Maserati Technical Bulletin

Date: June 4, 2018
Safety Recall Campaign # 369
Inspection/Replacement of the Front Suspension
Sub-frame - US
Supersedes: N/A
Section: Compliance

Model: Quattroporte (M156), Ghibli (M157) and Levante (M161)

Subject: Safety Recall Campaign # 369 – Inspection/Replacement of the Front Suspension Sub-frame

Fig.1

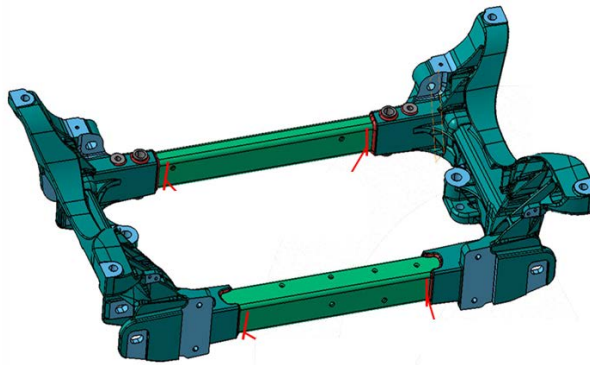
Maserati S.p.A. and MNA have determined that the above-described vehicles were manufactured with a front suspension sub-frame (Fig.1) that may have incomplete or missing welds. In certain circumstances, complete welds near the incomplete or missing welds may break and in some cases, the operators' control of vehicles could be diminished. This condition can cause a vehicle crash without prior warning.

Vehicles in the recall will require an underbody inspection to verify the sub-frame welds are all installed and complete. If a missing or incomplete weld is found, replacement of the sub-frame will be required.

1. Check that the vehicle is included in this recall campaign, and that this repair has not been previously performed.
2. Inspect the welds on the front suspension sub-frame, if necessary, replace the sub-frame.
3. The recall procedure is now complete.
